Amendment C387ggee to the Greater Geelong Planning Scheme

Expert Witness report provided to Planning Panels Victoria

Drainage Evidence

Prepared for the Developer Group (Stockland Land Lease Pty Ltd, Curlewis
Bellarine Pty Ltd, Curlewis Land Pty Ltd)

Figure 8: Plan used by Westlink to define the land valuation for DR-04

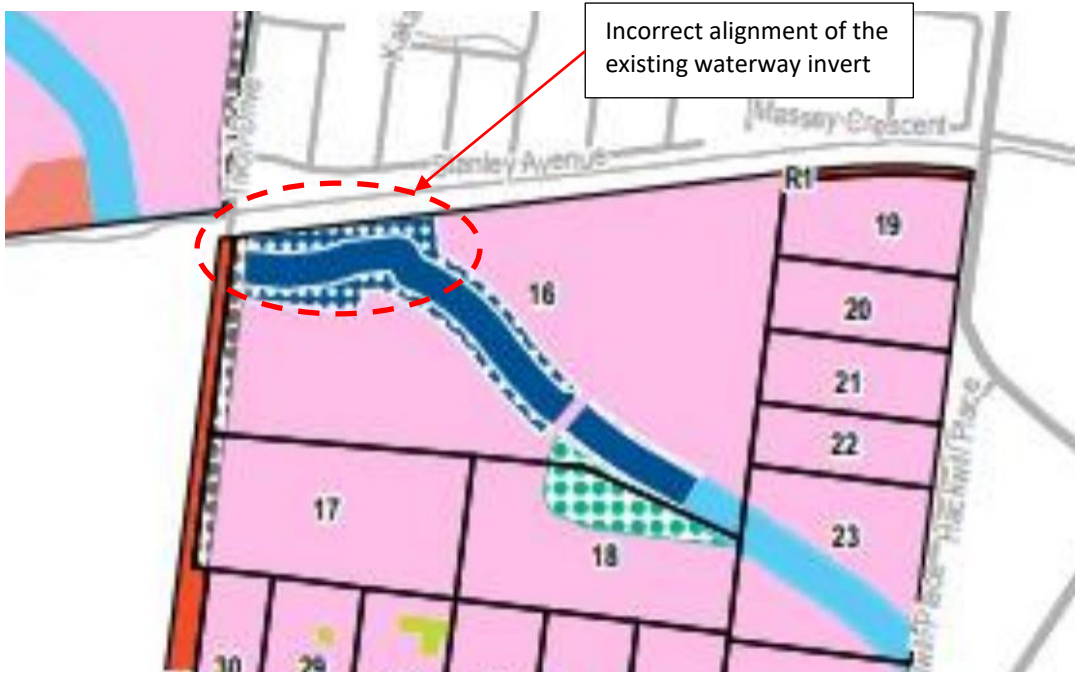
In calculating the land valuation for the DR-04 asset, which includes a corridor wider than 40 metres to accommodate wetland treatment assets, the 40 metre designated waterway corridor has been considered as encumbered and excluded from the valuation. Whilst I agree with the principle of this approach, there appears to be an issue associated with the alignment of the 40 metre waterway corridor. The plan used by Westlink Consulting (see Figure 8) in their document "Land Valuations" appears to have adopted an alignment for the invert of the existing waterway to be central to the proposed DR-04 drainage reserve. However in my opinion the actual existing invert of the waterway should be shown closer to the northern boundary of property. This is based on my assessment of field survey (see Figure 9), site inspection (see Figure 10) and Lidar survey data (see Figure 11).

In my opinion the alignment of the waterway encumbrance (40m) used to determine the Land Valuation by Westlink Consulting should be adjusted to follow the actual existing waterway invert. This is depicted in the plan prepared by SMEC (see Figure 12), which shows that the land outside the existing waterway encumbrance is 1.71ha compared to 1.544ha as shown by Westlink Consulting for the DCP valuation.

6. In my opinion the alignment of the waterway encumbrance (40m) used to determine the Land Valuation by Westlink Consulting should be adjusted to follow the actual existing waterway invert.

Figure 16: Cultural heritage salvage at property 15 (currently underway)

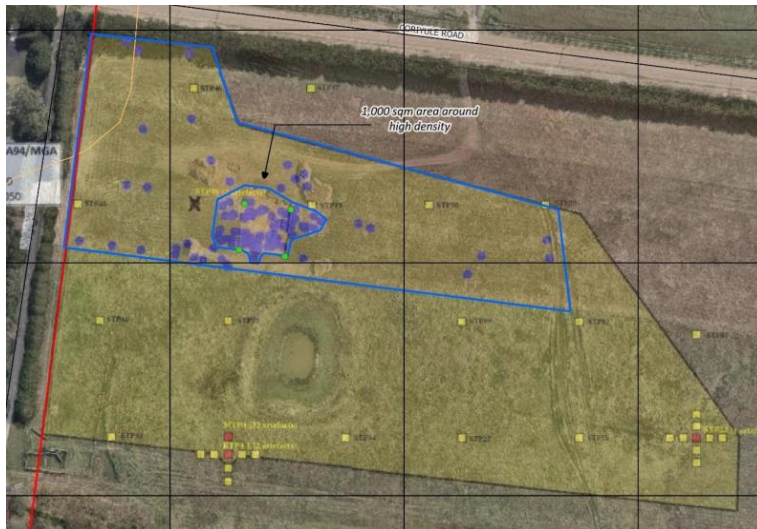
The outcome of the salvage operation may lead to a need to relocate the proposed drainage basin on the northwest corner of the property to avoid the Aboriginal heritage extent area outlined in blue (see Figure 16).

The impact on the local drainage strategy is difficult to define at this stage as it will depend upon the completion of the salvage works and be influenced by the revised urban design and civil engineering servicing. At worst it may require the wetland/retarding basin to be split (one to the south and one to the north-east). The key issue is that construction of a drainage pipeline will be required along the western boundary of Property 15 to enable the delivery of the DCP item known as DR-03. However in my opinion it is unlikely to have a material impact on the overall SWMS for Stage 2 (SWMS) as the overall discharge criteria for connection to the drain in Coriyule Road will remain unchanged.
